Access Compliance Report

Public Rights-of-Way

(Curb Ramps)

Intersection ID: 21168	Main Street: LONG_MEADOW_RD	Cross Street: SULKIRK_RD	Location: NE
ADA ID: 927DEC80E968	Ramp Type: PerpDiag	Initial Pass/Fail: Fail	Overall Compliance: No
Codes/Mitigation Info/Possible Solution		Field Measurements/Component Compliance

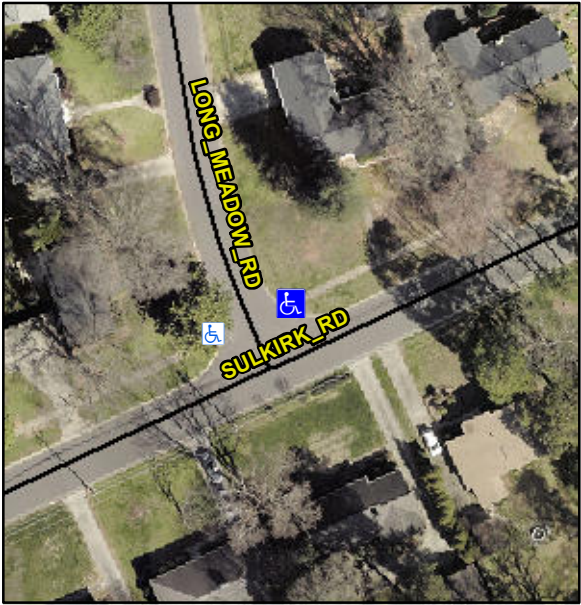
Possible Solutions:	Compliance	Description	Data	Compliance	Description	Data
	Remove & Replace Curb Ramp With Two New Directional Ramps or Equivalent.	N/A	Ramp Length (in)	73.0	No	Ramp Slope (%)	12.2
<p>Surveyor Notes:</p> <p>N/A</p> <p>PROW/ADA:</p> <p>Not Found, R304.2.2, R304.5.3</p>		Yes	Ramp Width (in)	48.0	No	Ramp XSlope (%)	3.9
		N/A	Flare Type LT	N/A	N/A	Flare Type RT	N/A
		N/A	Flare Slope LT (%)	N/A	N/A	Flare Slope RT (%)	N/A
		N/A	Flare Traversable LT?	N/A	N/A	Flare Traversable RT?	N/A
		N/A	Landing Length (in)	N/A	N/A	DWS Provided?	N/A
		N/A	Landing Width (in)	N/A	N/A	DWS Contrast?	N/A
		N/A	Landing Slope (%)	N/A	N/A	DWS Length (in)	N/A
		N/A	Landing X Slope (%)	N/A	N/A	DWS Full Width?	N/A
		N/A	Landing Curb? (Y/N)	N/A	N/A	DWS Offset (in)	N/A
		N/A	Shared Landing?	N/A			
		N/A	Gutter Ponding?	N/A	N/A	Gutter Slope (%)	N/A
		N/A	Gutter Lip Ht (in)	N/A	N/A	Gutter X Slope (%)	N/A
		N/A	Painted X Walk1?	No	N/A	Painted X Walk2?	No
